# FREEDOM HIGH SCHOOL AUXILIARY GYM

## Addendum 02

5/20/2021

**Architect's Project No.: 1869.00**

10 BASKETBALL HOOP FOUNDATION

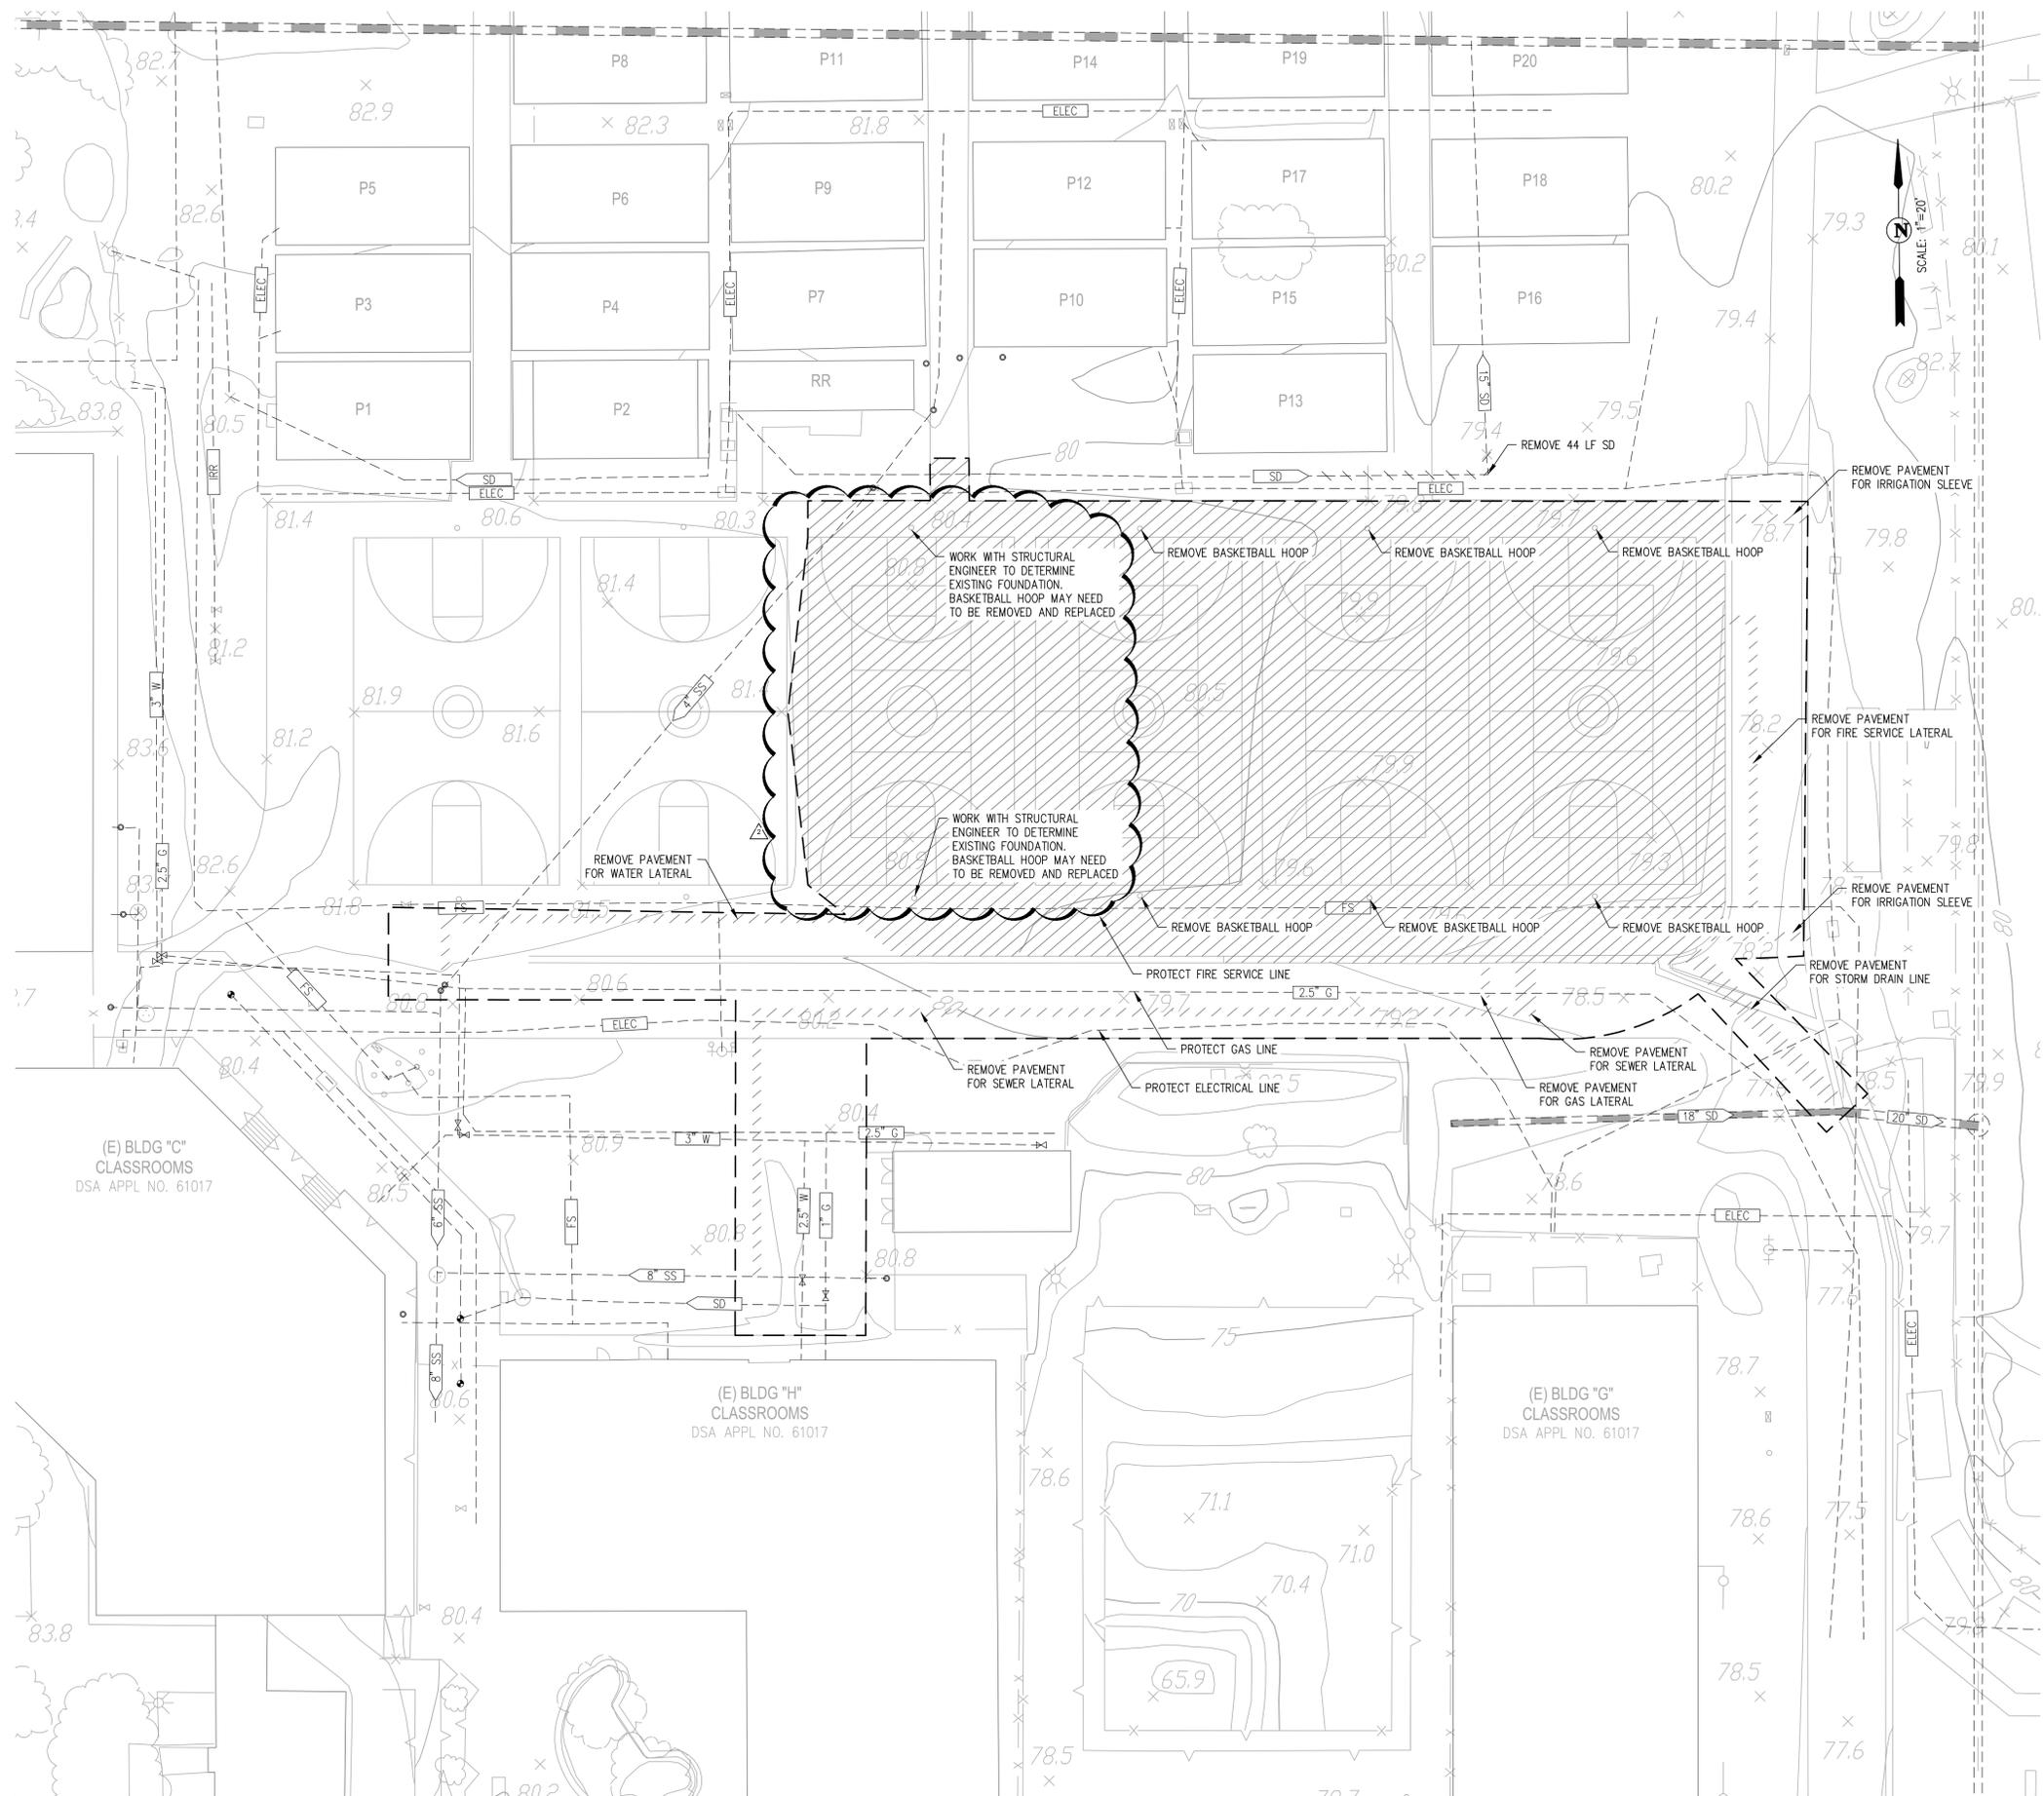
Sheet S-M4.1 Foundation Details

Add detail 10 Basketball Hoop Foundation with the attached drawing ADD 02.01.

Pending DSA review and approval, it is structurally acceptable to provide a pier foundation at the existing outdoor basketball hoops per detail added to S-M4.1.

**NOTE:**  
 BASKETBALL HOOP  
 MAX AREA: 25 FT<sup>2</sup>  
 MAX WEIGHT: 1000#
